- 1. Call to Order and Pledge of Allegiance
- 2. Roll Call
- 3. Approval of Minutes
 - October 1, 2025 [Pages 3-6]
- 4. Public Comment
- 5. Scheduled Business
 - A. (Continuance) HI-10/11-25, Type III Quasi-Judicial Process [Page 7]

Staff Report

Historic Review of Exterior Alterations

HI-12-25 September 24, 2025

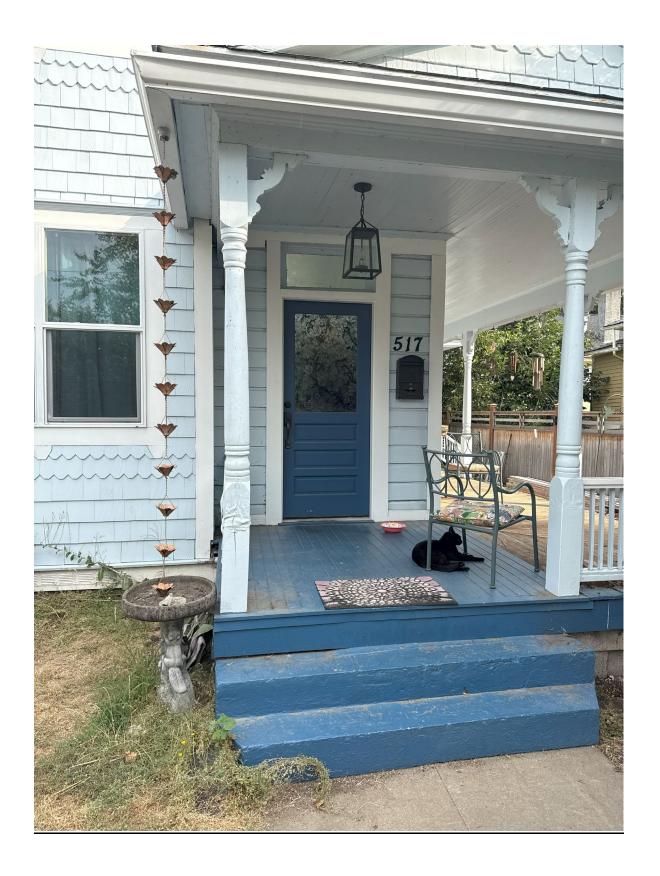
Greg Nicol didn't have anything to add to the application but was present to answer any of the Commissioner's questions. He was hoping to change the Eastlake style posts to an Italianate Style. He is happy to make alterations to the Eastlake style if necessary to get the project complete and retain historic value.

Commissioner Winterrowd pointed out that the posts have survived and for this particular house she didn't support a change in the post design but agreed replacing it with one of the other posts or repairing it is preferable and even if all were replaced, they need to be replaced in kind.

Commissioner Settlemier noted based on the information he could find the wraparound porch was added during the time an addition was built. And with the Eastlake styling the survey of the house calls out the turned posts as a character-defining feature of the house. He noted when there is a character-defining feature it should be maintained. And as the other posts have not been determined to be beyond repair, he doesn't support the change.

This application proposes to replace the current turned posts that are badly rotten (and have already been repaired once) with posts that are classically Italianate using square posts with stopped chamfers while retaining all other architectural features of the home (corbels, balustrades).

Conclusion: The proposed alteration is more in line with traditional Italianate construction than the existing porch posts. Mass, size, scale, materials, and architectural features of Italianate houses of the same era were all researched and taken into consideration when drafting this proposed change.
